Submission response—Possible amendments to telecommunications powers and immunities

Jim Pruss, Chief Executive Officer
Queensland Bulk Water Supply Authority trading as Seqwater
Level 8, 117 Brisbane Road,
Ipswich Q 4305

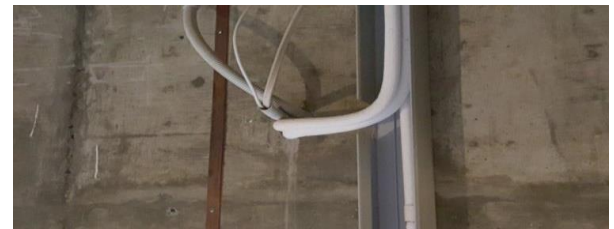
Seqwater has seen workmanship issues from the installation of low impact facilities by carriers and lack of maintenance/upkeep (refer to Photographs No. 5, 6 and 7). There have been gaps from probes to feed Seqwater's Supervisory Control and Data Acquisition (**SCADA**) which over time wears from weather impacts. There has been vermin ingress to our water supply reservoirs at these points which can also impact drinking water quality.
